# Safety Alert 029

Title: Intergas HRE 36/40 & HRE 40SB Front plate Seal Upgrade

Date issued: 28 February 2019

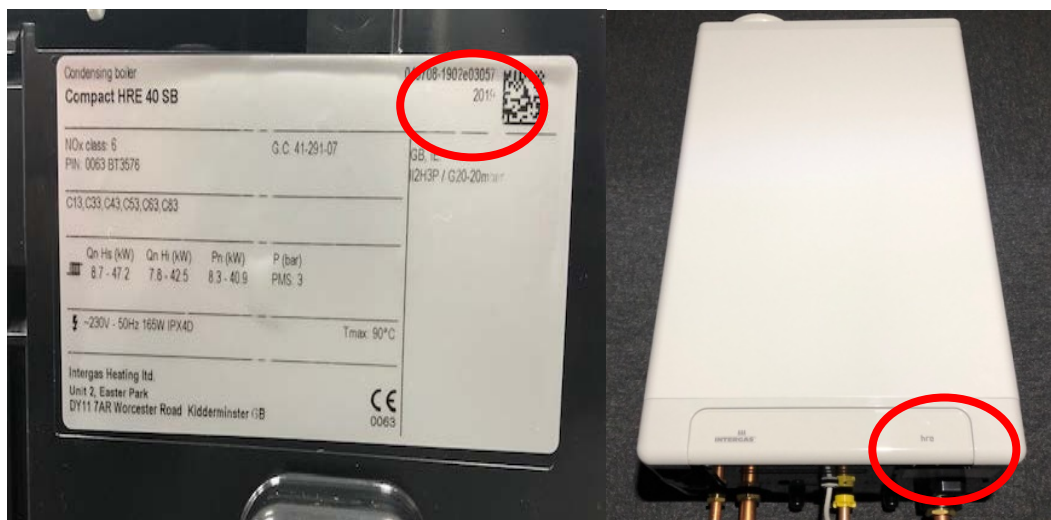
The HRE 36/40 & HRE 40SB products have had a front plate seal upgrade to improve longevity which has been identified as a safety concern.

For safety reasons all boilers produced within serial batch numbers **1210g09094** to **1611e17513** must be upgraded with the new Viton black seal.

The front plate seal has been upgraded from the red seal to the new black seal. The part number for the new black seal is 620274.

Please contact Intergas to check if this seal has already been replaced or if necessary make an appointment for an Intergas engineer to attend.

Where the integrity of the front plate seal has been affected the current Gas Industry Unsafe Situations Procedure (GIUSP)<sup>(1)</sup> should be implemented and the appropriate actions and warning notices/labels completed and issued.
